TRANSMITTAL

PROJECT : MMCEASTTOWER
CUST. NO. : 310

VIA : CUSTOMER WEB SITE
FOR : APPROVAL

Submittal No. 051200-0005-0

JOB NO.	DRG. NO.
7272	E10-60B

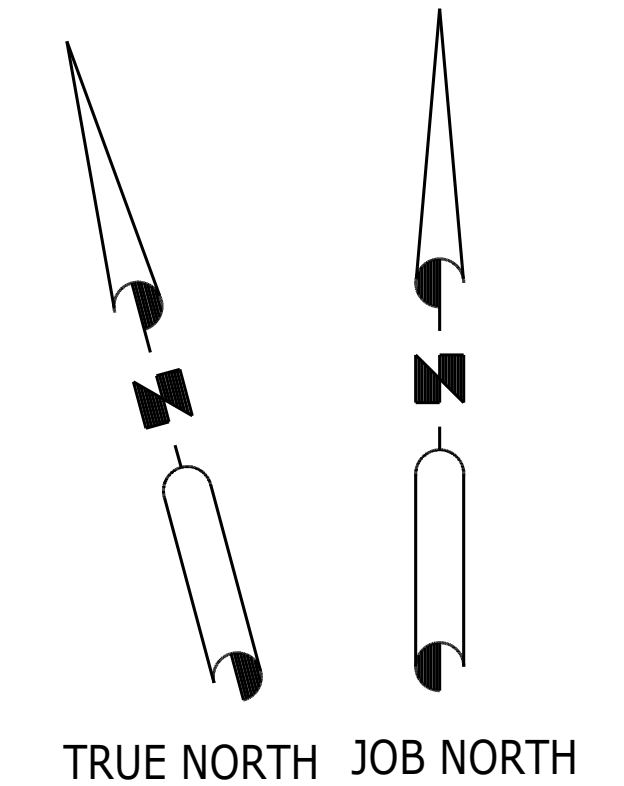
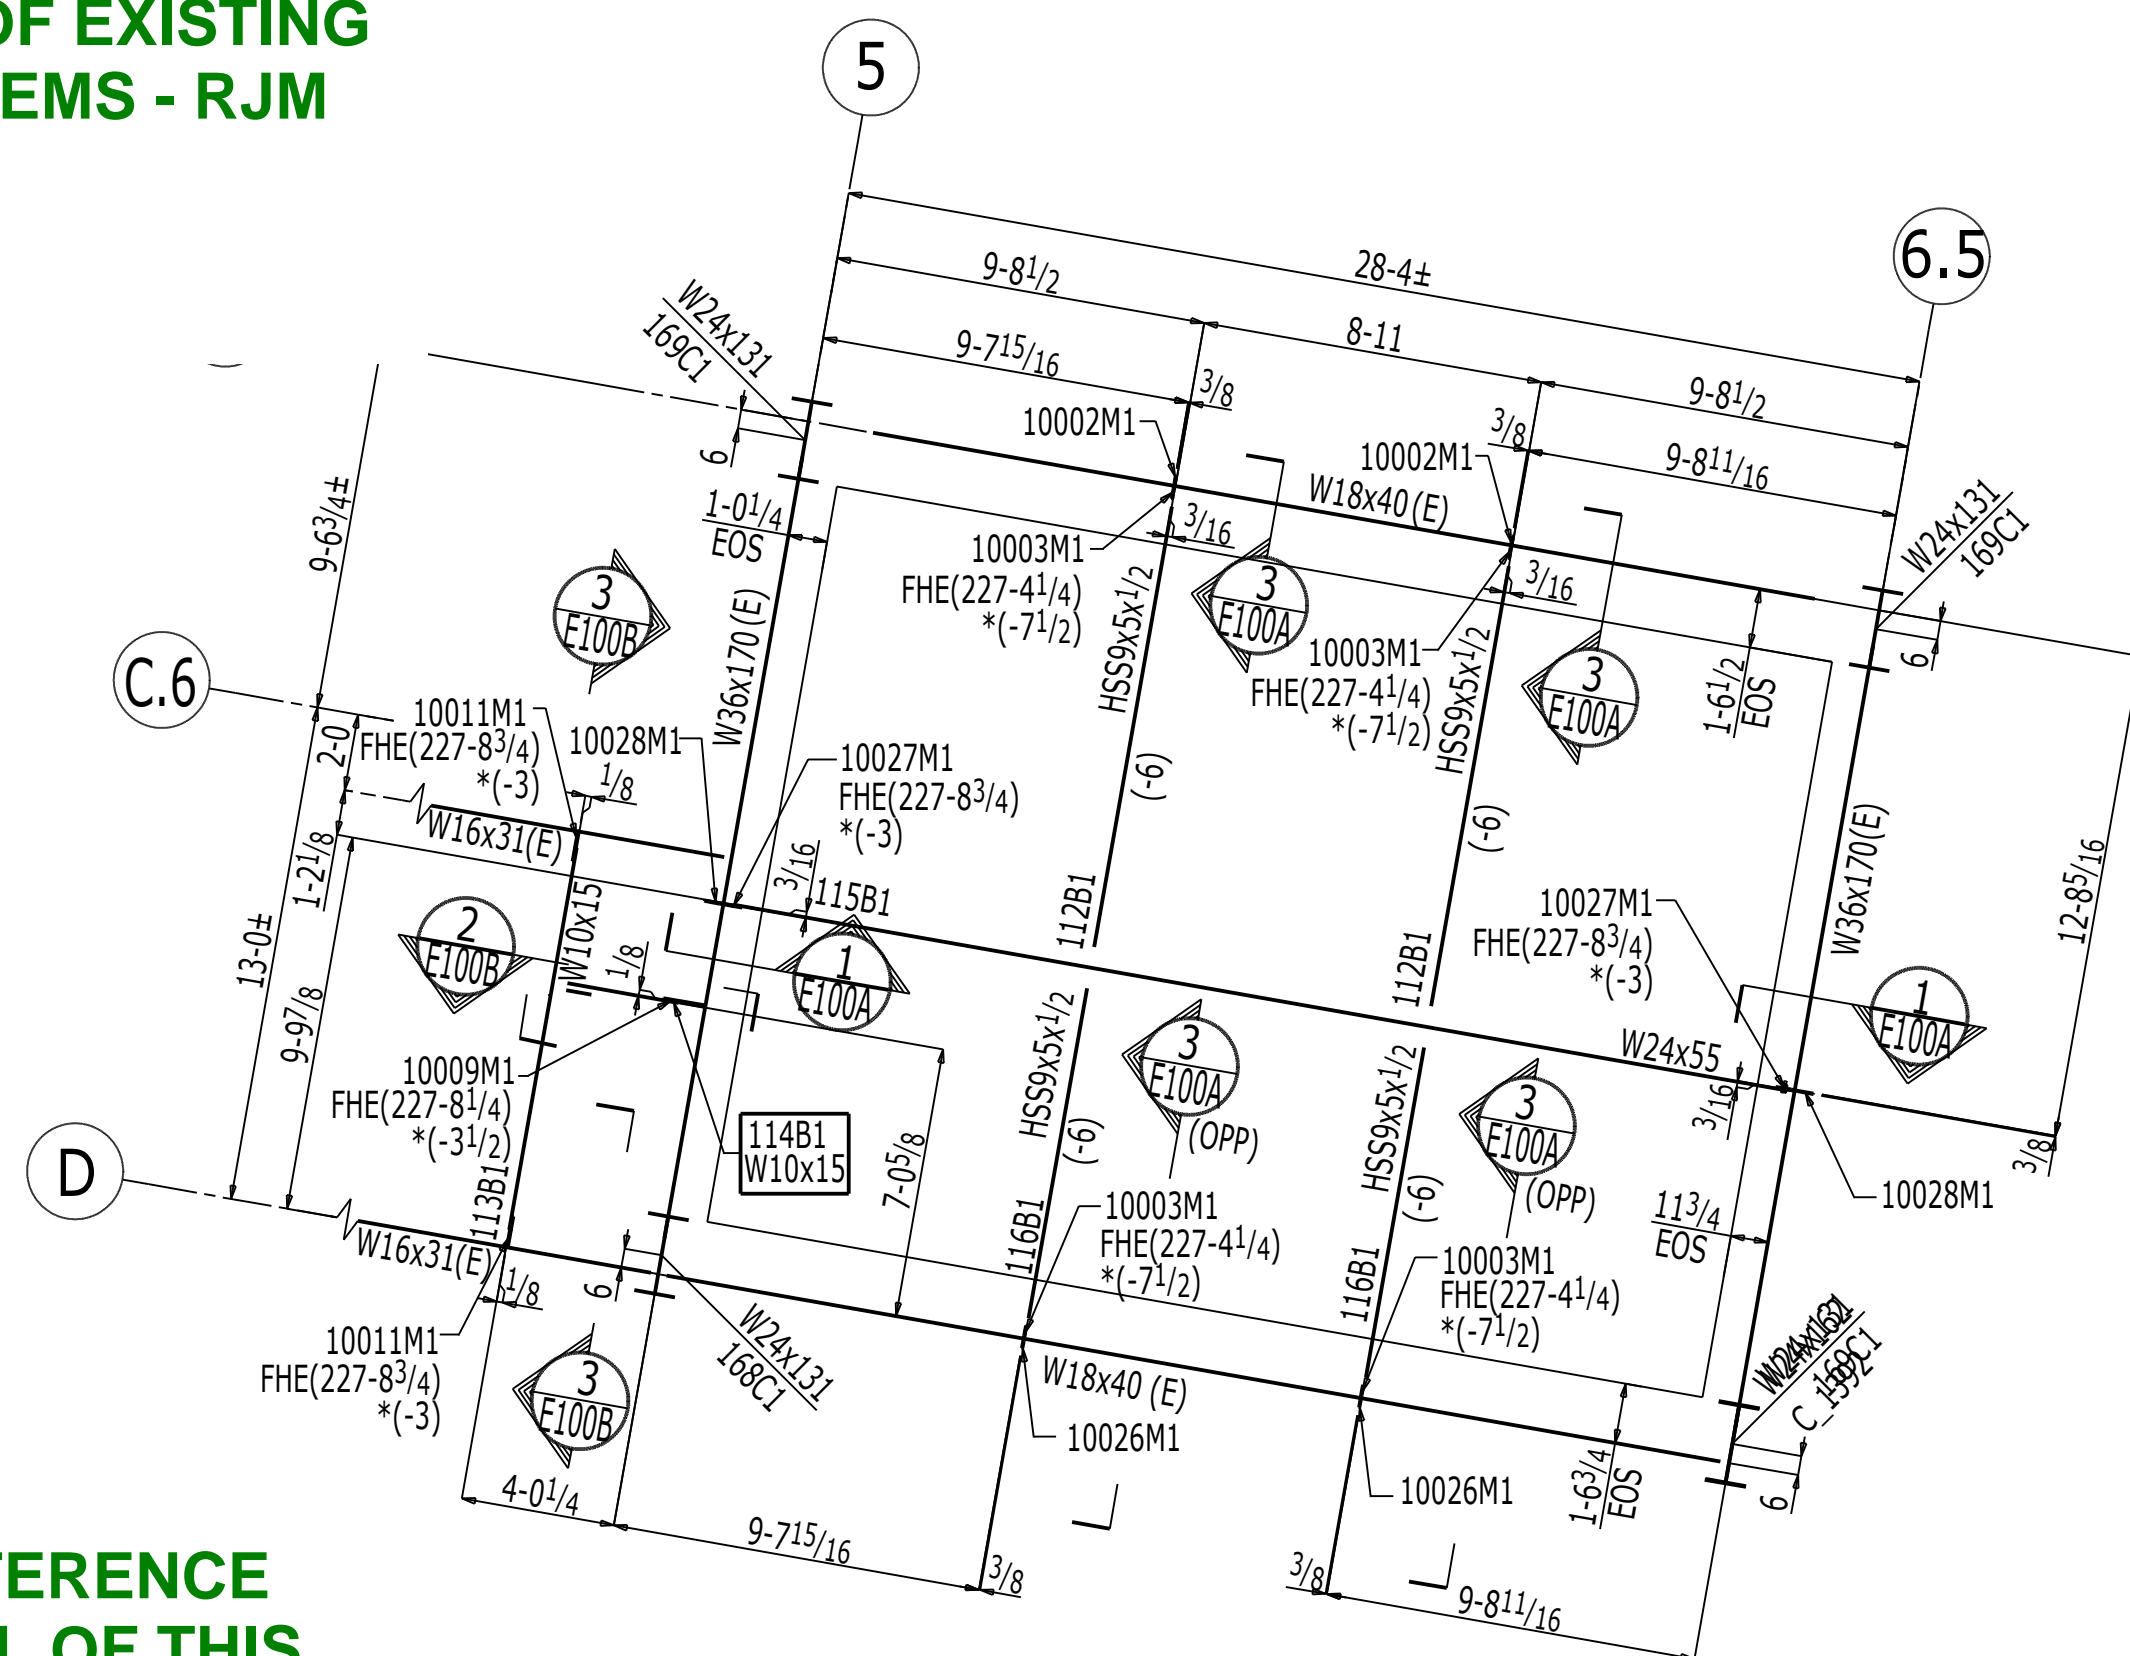
ALL MEP OPENINGS SHALL BE COORDINATED AND VERIFIED TO MEET REQUIREMENTS OF EXISTING MEP AND NEW MEP SYSTEMS - RJM

ALL ELEVATOR STEEL SHALL BE COORDINATED WITH ELEVATOR SUBMITTALS PRIOR TO FORMAL APPROVAL - RJM

JOB NO.	DRG. NO.
7272	E10-60C

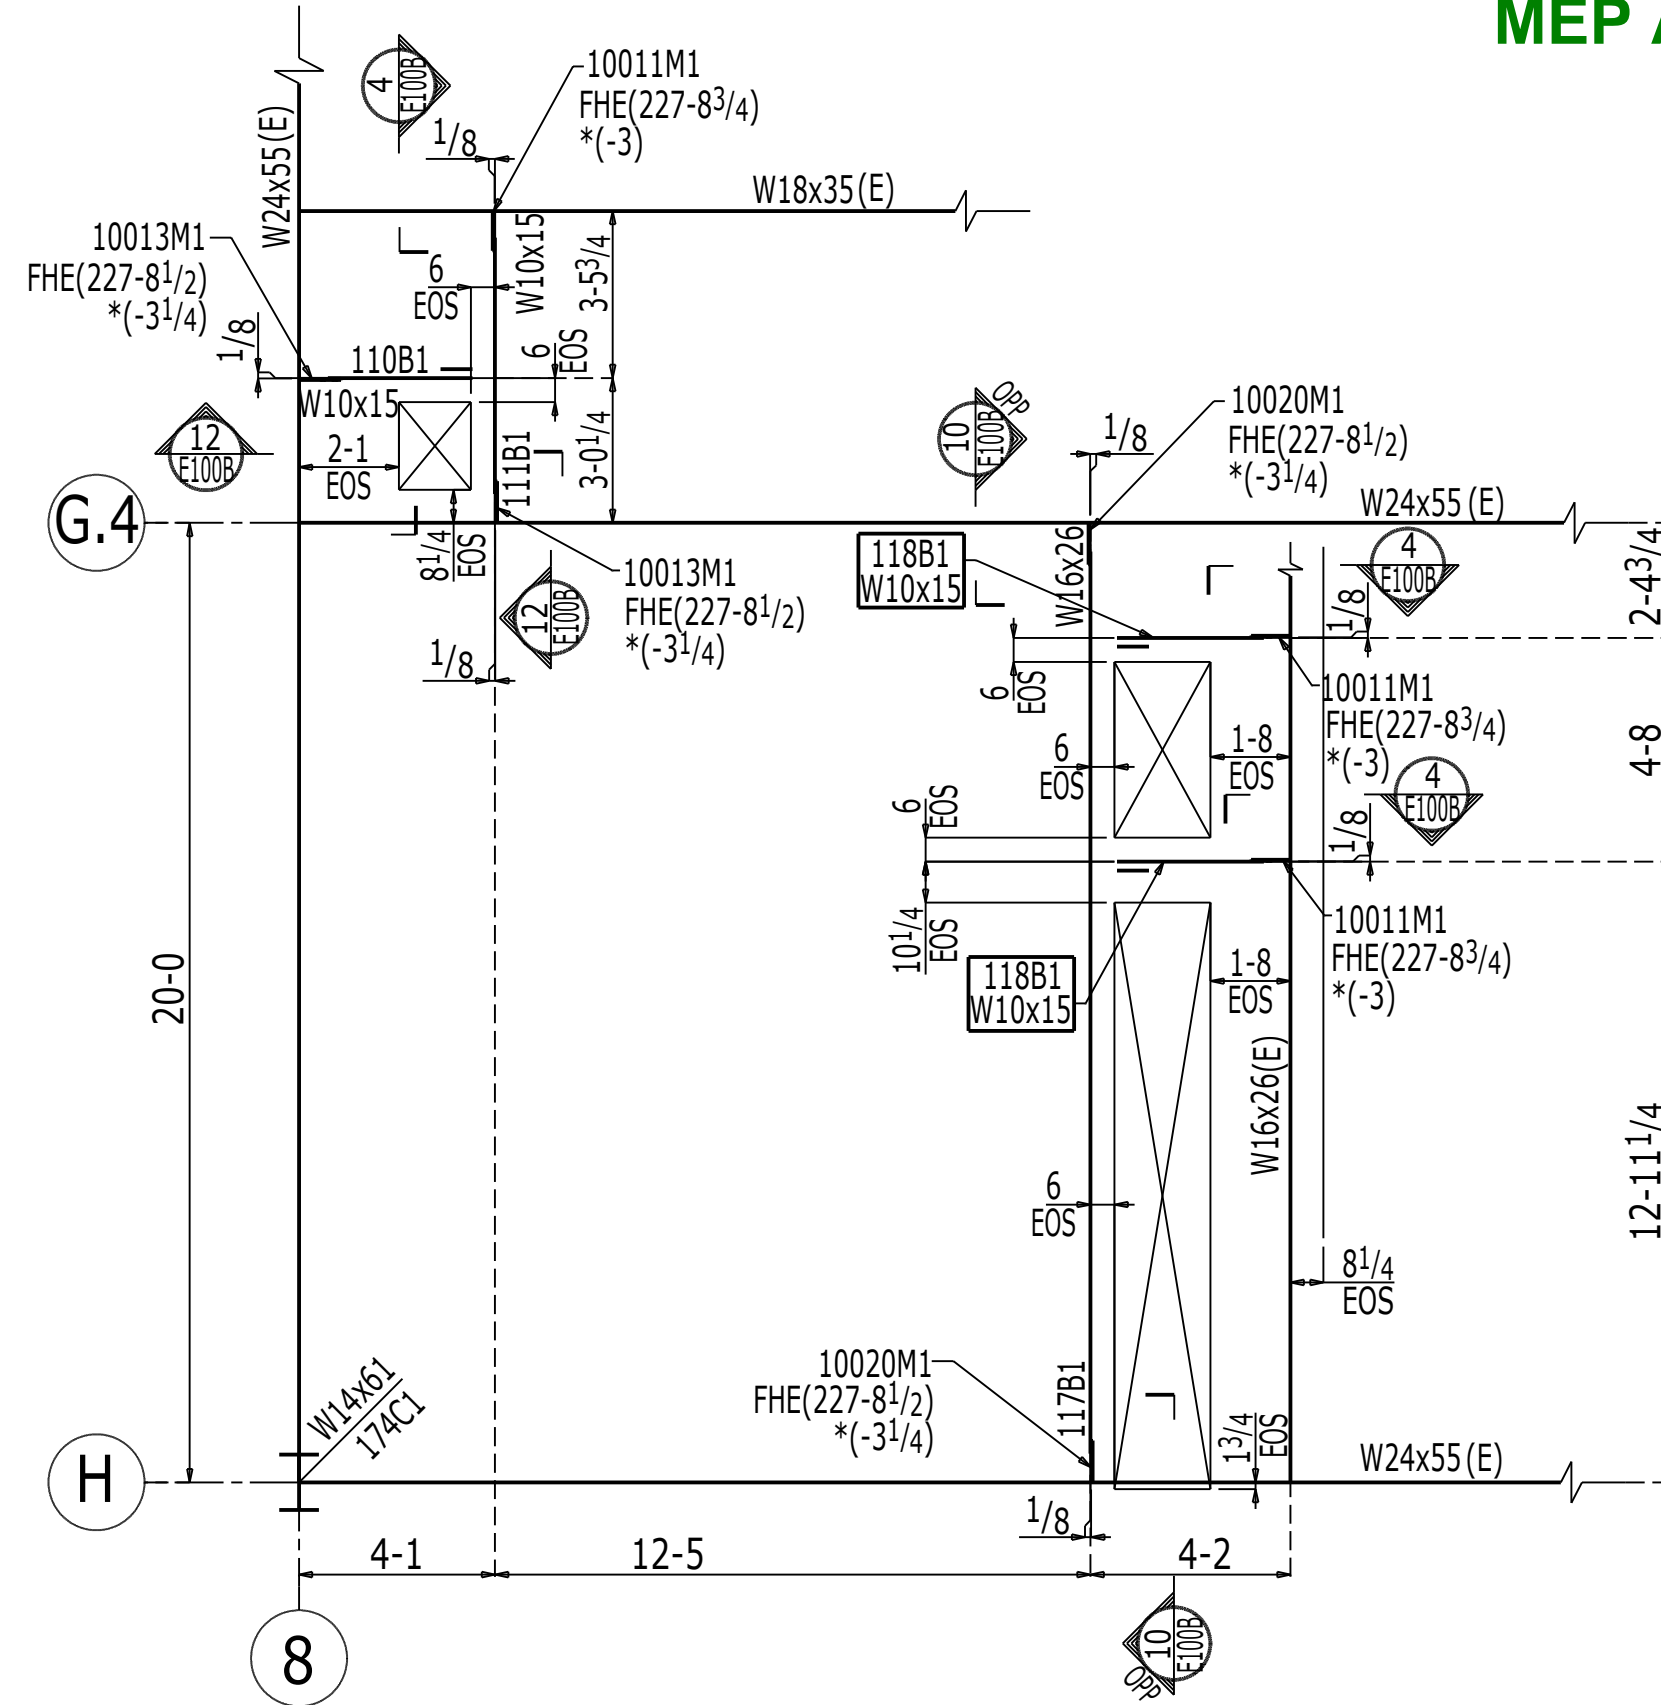
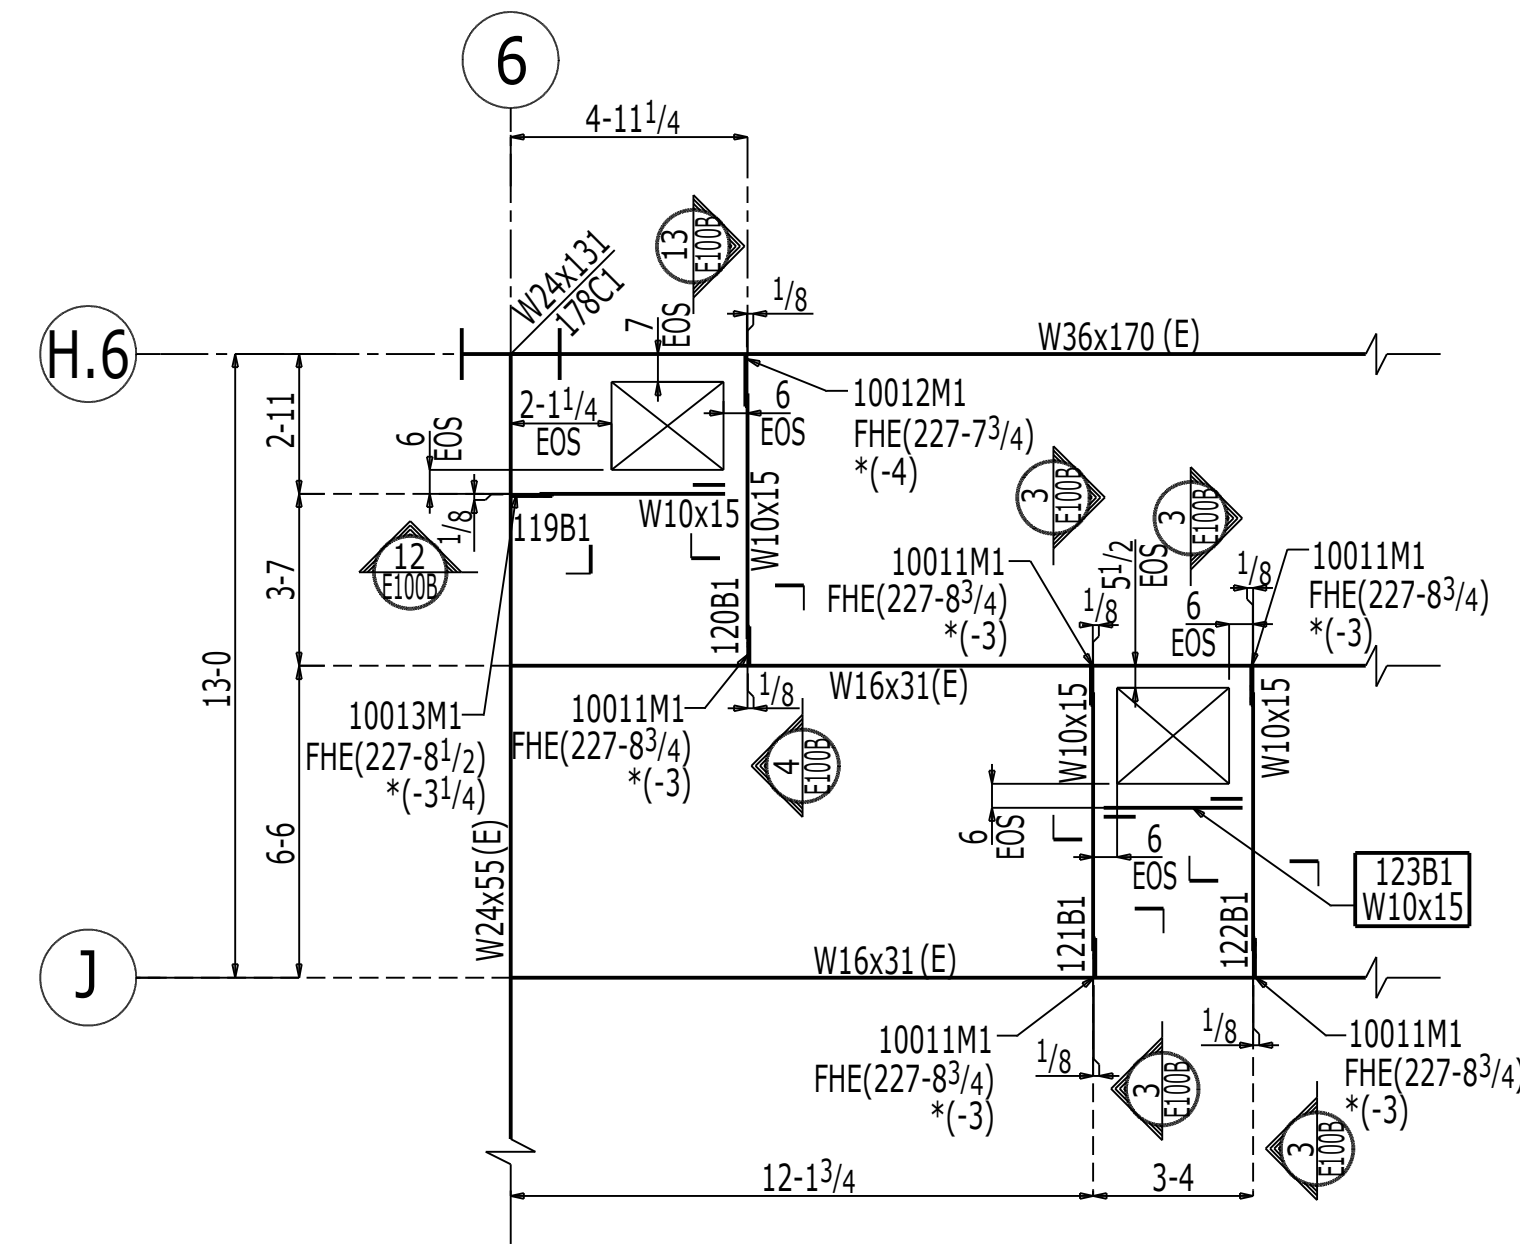
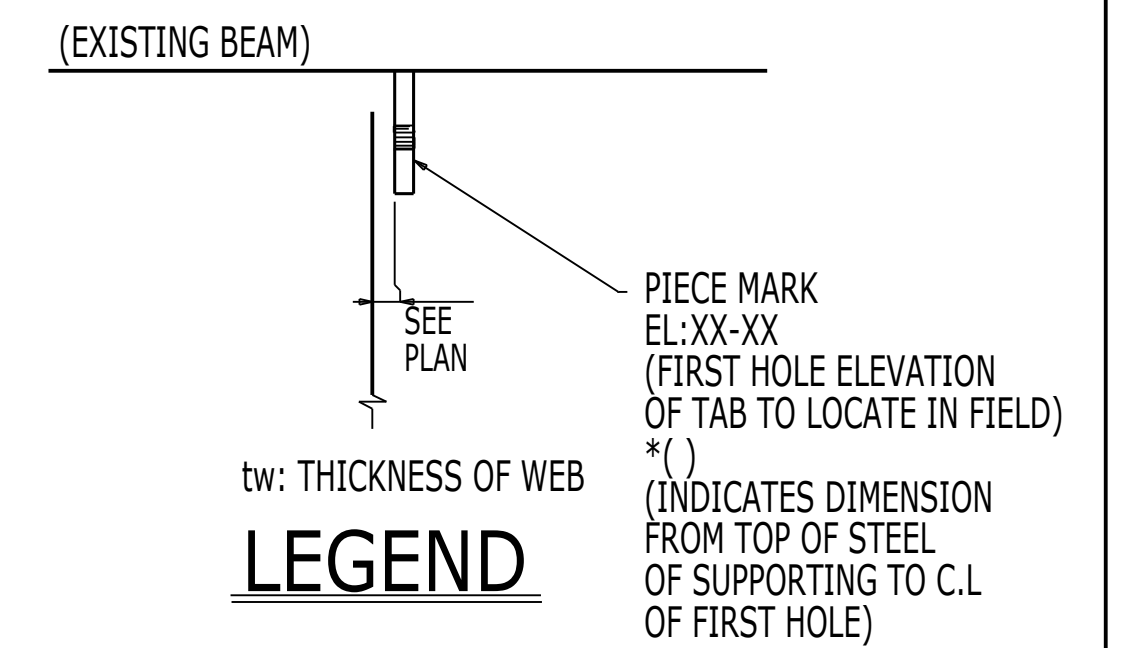
ALL MEP OPENINGS SHALL BE COORDINATED AND VERIFIED TO MEET REQUIREMENTS OF EXISTING MEP AND NEW MEP SYSTEMS - RJM
